SERVICE BULLETIN

SUBJECT TR-7950/30 RX Interference	DATE 4.8.83
---------------------------------------	----------------

Fig. 1

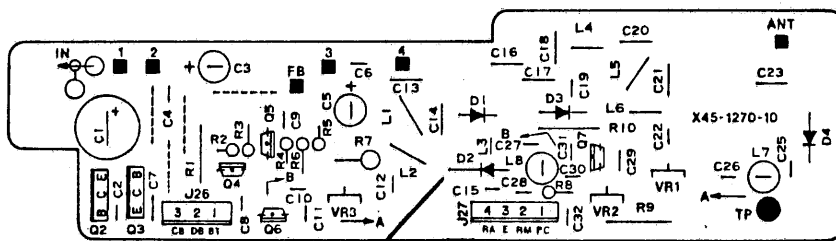
1. Remove the top and bottom covers.
2. Remove the 4 screws that secure the heat sink assembly to the rear of the set. Gently pull the heat sink assembly to the rear, to allow access to the final unit (X54-1270-10,11).
3. Remove the 5 screws securing the PC board to the heat sink. Remove the 2 screws securing the final module (M5733/M57726) and remove the screw that secures Q2 to the heat sink. Carefully desolder L9 from the antenna connector.
4. Gently fold the assembly over to allow access to the foil side of the final assembly and remove D2, (Figure 1), and replace it with the MI-308.
5. Reverse steps 1-3 to reassemble. See figure 2 for proper connection of L9. Use heat sink compound when replacing the final module.
